City of Portland, Maine – Building or Use Permit Application, 389 Congress Street, 04101, Tel: (207) 874-8703, FAX: 874-8746

BUILDING PERMIT REPORT

DATE: 17 OCT. 98 ADDRESS: 304 Summit St. CBL 382-C-15
REASON FOR PERMIT: To Construct approx 28' Shed downer
BUILDING OWNER: Tim & Beth Kane
CONTRACTOR: A.C. Carpentry
PERMIT APPLICANT: owner

Front wall of Dormer not to scale

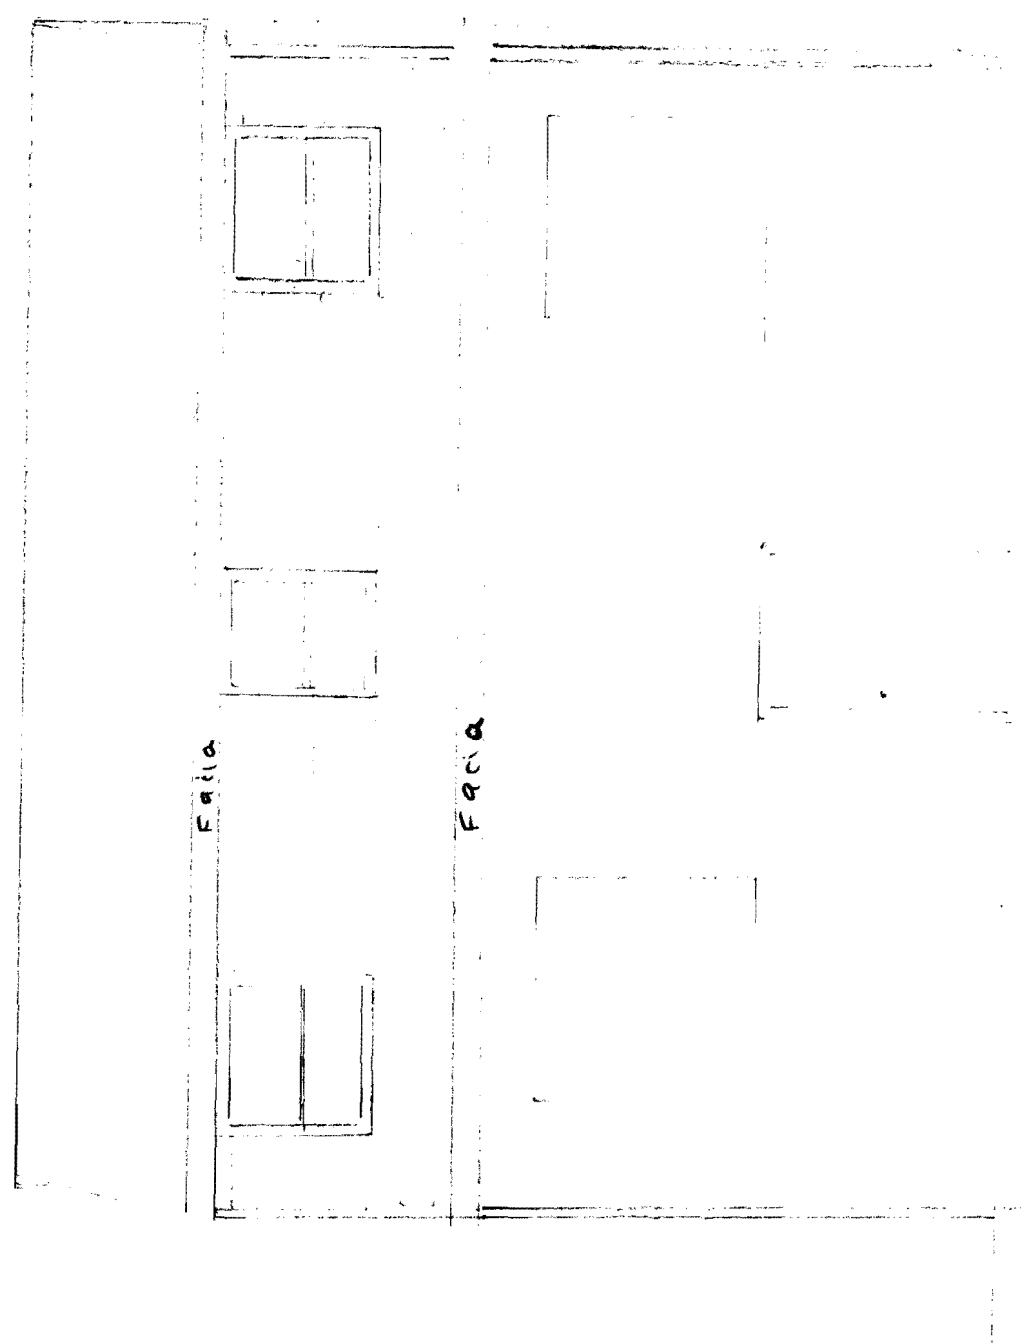
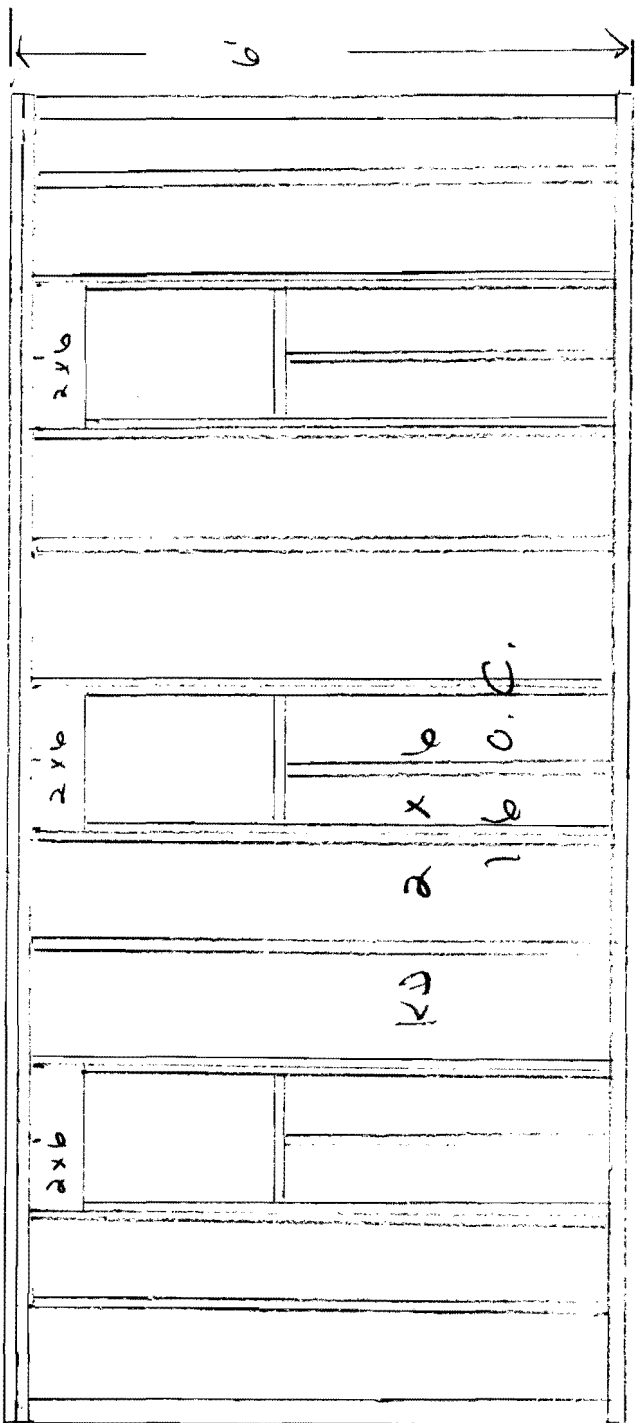
- 30. Glass and glazing shall meet the requirements of Chapter 24 of the building code.
- *31. *Your proposed plan shows 2x8 rafter but does not show spacing or length of the rafters. (2x8 @ 16" OC, max span for rafters would be 10' - Before work begins you must re-submit a more detail rafter design - For review - you may fax this info. to me @ 874-8716. Please state name, address location of job. SAM HOFFES ATEN.*
